Knit Asia Limited

East Narshingapur, Ashulia, Savar
(+23.930205N, 90.309940E)

01 October 2013

Load management in storage

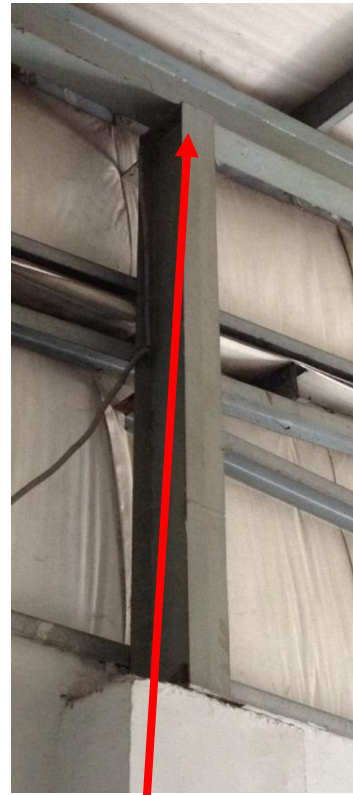
Load management storage (high density items)

Plan and height restrictions in place to consider high density loading to prevent future overloading.

Restrictions for high density loading to be based on design floor loading.
